UNITED STATES OF AMERICA  
NUCLEAR REGULATORY COMMISSION  
BEFORE THE ATOMIC SAFETY AND LICENSING BOARD

In the Matter of  
THE REGENTS OF THE UNIVERSITY  
OF CALIFORNIA  
(UCLA Research Reactor)

Docket No. 50-142  
(Proposed Renewal of  
Facility License)

COMMITTEE TO BRIDGE THE GAP'S SUPPLEMENTAL CONTENTIONS  
TO PETITION FOR LEAVE TO INTERVENE

Fig. 19. UCLA reactor-core area.

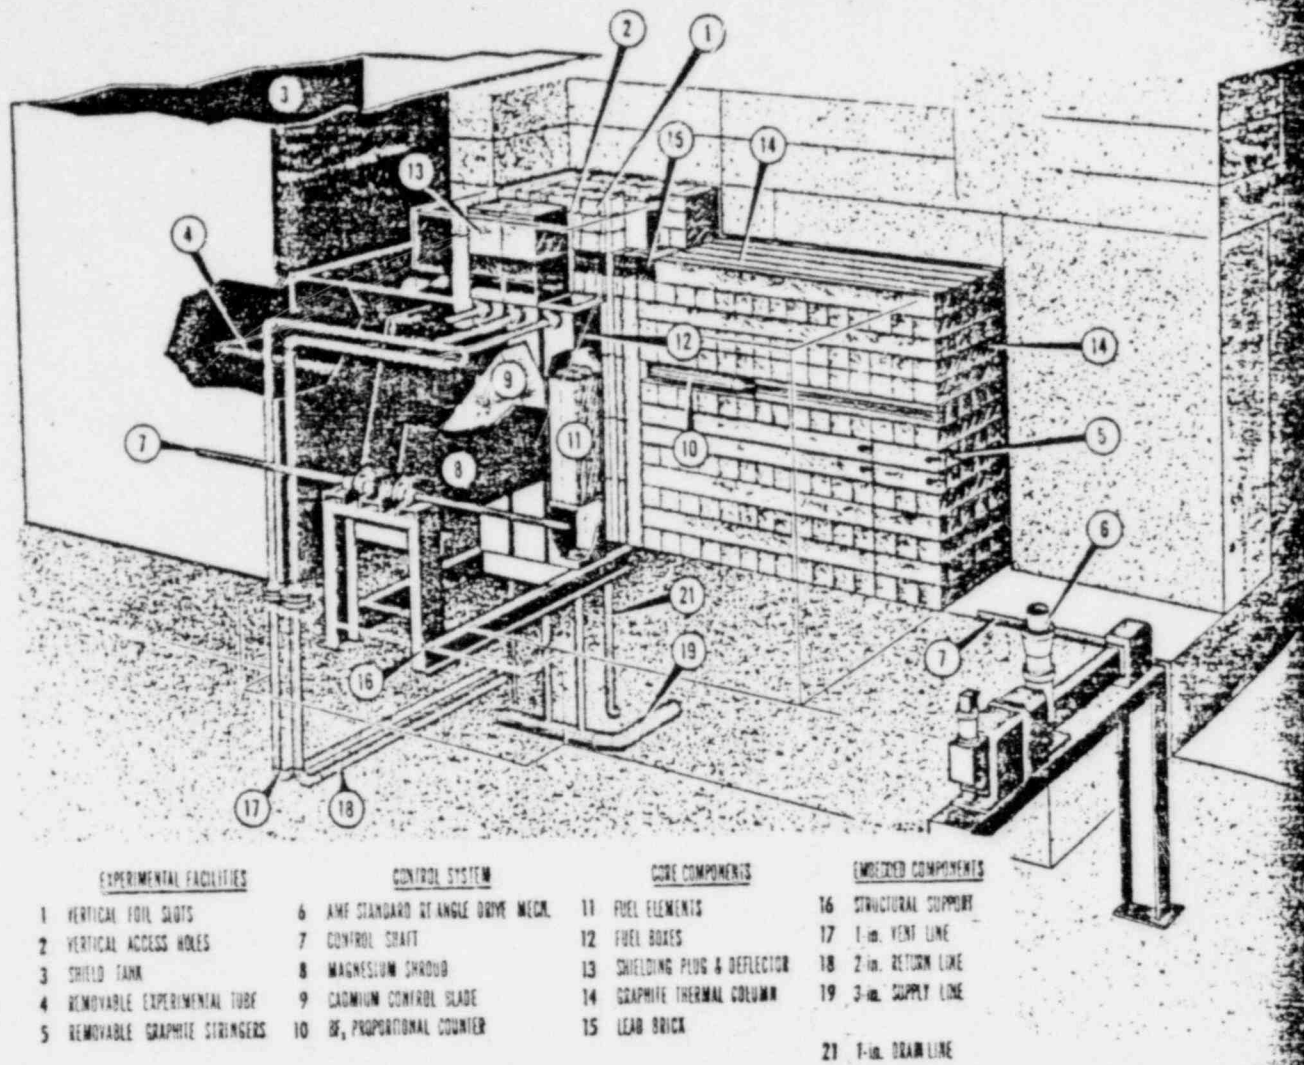
However, Applicant failed to state that the UCLA reactor failed the test in question and that damage to the reactor was so severe that a control blade eventually stuck in the outposition, requiring dismantling of the reactor core, necessitating substantial radiation exposure to repair workers and raising serious questions about the safety of the UCLA reactor in case of an earthquake. The report the Applicant cites above without describing its contents states the following:

None were observed. About 6 months after the vibration experiment routine tests indicated that one of the control blade insertion times had increased. A few months later safety blade No. 1 stuck in the "out" position during a routine prestart checkout of the reactor control system.

FIG. 3-30 Predicted and measured nuclear energy release vs. period for BORAX-1, SPERT-1, and SL-1. Total energy unless otherwise specified. Circles are BORAX data from reference [19], squares SPERT-1 DU 12/25 data from [65a] and triangles SPERT-1 destructive test data from [65].

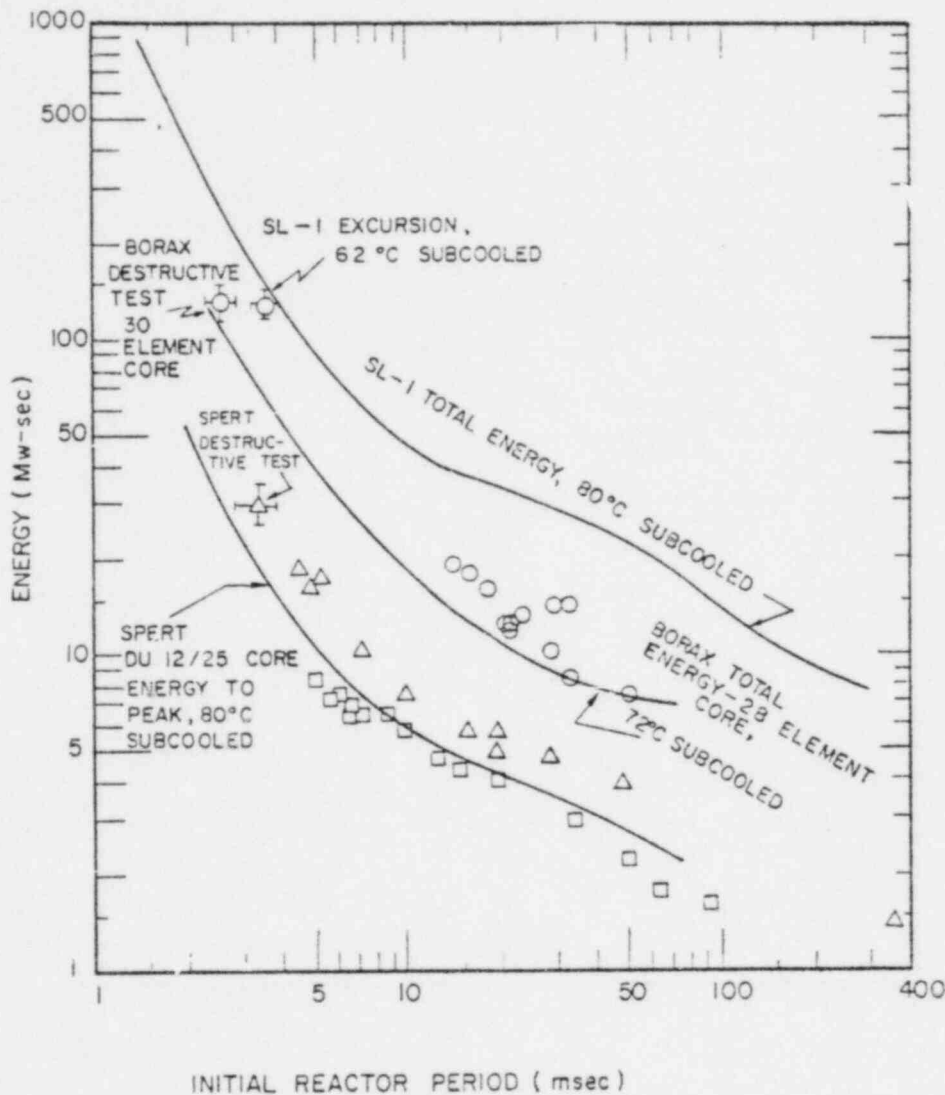
c. The SAR uses as a "constant" an interpolation off a line drawn imposed on 21 data points from the Borax I experiment. (see chart marked Figure D-5 at the end of this contention). The line itself is a rough approximation on a log-log chart with the line only capturing 5-7 points plotted, with no data points located anywhere in the range of the point of interpolation. There is obviously a significant probability of error involved here, particularly on a log-log chart like this, but no error bars are given, in the absence of which, a significant extra safety margin must be made.

16. The Borax data itself needs error bars. Thompson and Beckerly p. 623 indicate that "the somewhat unexpected destructiveness of the test resulted in losing some information which might have been gained. They continue: "Instrumentation and other means for obtaining information from transient tests should be planned on the basis of overestimates of the possible destructiveness of the tests if maximum information is to be gained." They report the period as .0026 seconds, describing it as "the minimum period measured," so the few data points that are charted for Borax in the Hazards Analysis may not be as firm as one would like. It is clear from the H.A. chart that there are no data points in the region of interest, that all that is done is extrapolation.

Fig. 19. UCLA reactor-core area.

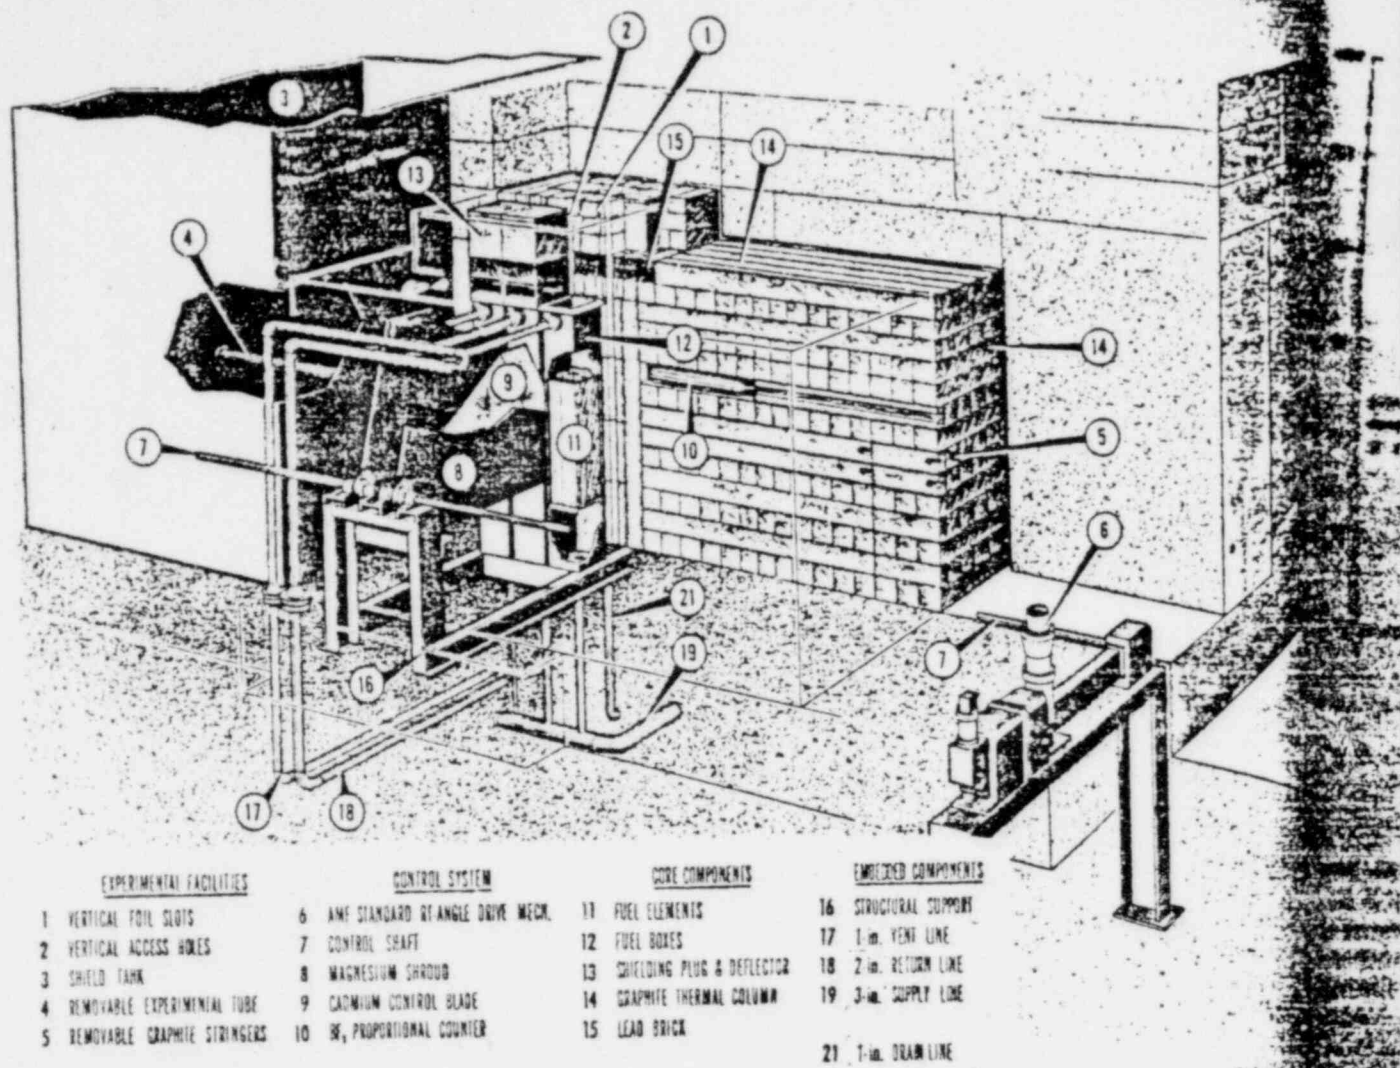
None were observed. About 6 months after the vibration experiment routine tests indicated that one of the control blade insertion times had increased. A few months later safety blade No. 1 stuck in the "out" position during a routine prestart checkout of the reactor control system.
